PUBLIC UTILITIES COMMISSION

RE: Mesa 500-kV Substation Project – Minor Project Change No. 9 Request: Telecom Conduit Undergrounding

MPC No. 9 Request Figure and Work Area Photos

MINOR PROJECT CHANGE NINE

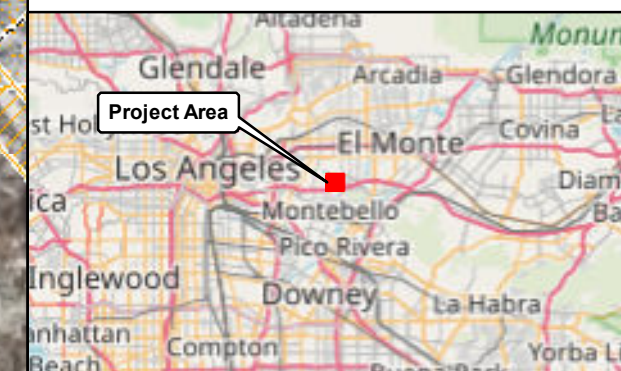
On October 8, 2019, Southern California Edison (SCE) submitted Minor Project Change (MPC) No. 9 Request to the California Public Utilities Commission (CPUC) for review. The proposed MPC would involve installation of approximately 600-feet of two new 5-inch conduits between the existing manhole on the east side of the Service Center wall (M5654776) and the existing vault on the south side of Potrero Grande Dr. (V502272); adjacent to the Service Center driveway.

Approximately 500-feet of this underground infrastructure would be installed via horizontal directional drilling (HDD) to minimize potential disturbance to the surrounding landscape and to facilitate ease of construction. One bore pit would be established at the vault location adjacent to the Service Center Driveway V5022702; with a receiving bore pit at the existing manhole M5654776. The vault tie-ins would be installed via an open trench method. The remaining trench for this undergrounding would be approximately 2 feet wide and approximately 5-feet deep and 50 feet-long at each end of the vault and manhole locations. Soil would be stockpiled adjacent to the trenching, and the trenches would be partially backfilled with 2-sack concrete slurry and topped off with native soil when construction is complete. All unused soil would be transported to the Mesa expansion site. Equipment used to install these conduits would be similar to equipment that has already been utilized for similar activities on the Project (e.g., one small backhoe for the duration of the work, etc.) After these conduits are installed, the existing cables in the constrained conduit path route would be removed and rerouted through this new conduit path. The removal involves pulling the cables from the existing structure and would not require any trenching.

The installation of approximately 600-feet of two new 5-inch conduits described above is proposed because SCE's information technology department's cable requirements became more defined as the Mesa 500-kV Substation Project construction progressed, and the existing 1-4-inch conduit path along the existing telecommunications route would be too small to support the necessary number and sizes of cables required with the current design. Therefore, an additional

The CPUC has determined that MPC No. 9 meets the above criteria. MPC No. 9 is approved by the CPUC for the proposed activities based on the factors described below.

MPC No. 9 is approved by the CPUC with conditions. The conditions presented below shall be met by SCE and its contractors:
